IN THE MATTER Proposed Plan Change 50 to
the Queenstown Lakes
District Plan

**STATEMENT OF SUPPLEMENTARY EVIDENCE
OF ALEXANDER DAVID GIBBS
FOR BRECON STREET PARTNERSHIP LIMITED**

Dated 15 January 2015

Figure 1: Campground Shadow Analysis on June 21

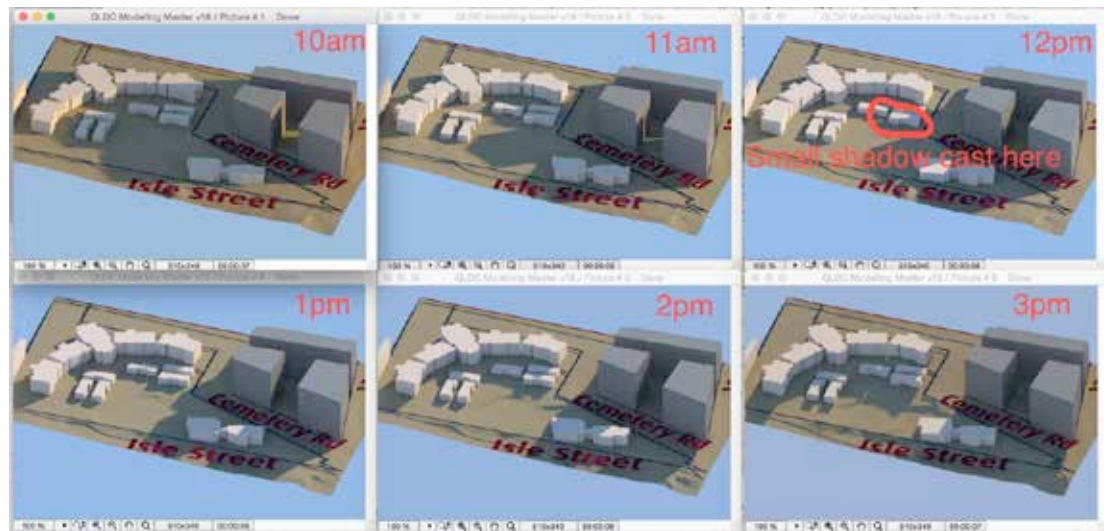
15. The shadow diagrams show that all adjacent buildings are exposed to sun from 10am (**Figure 1- Appendix F**), even on the winter solstice on 21 July. In my opinion they are not significantly adversely affected because six of the seven buildings will have access to sun by 12pm, which is an important time of day for sunlight as it is a common time for people to take a lunch break.
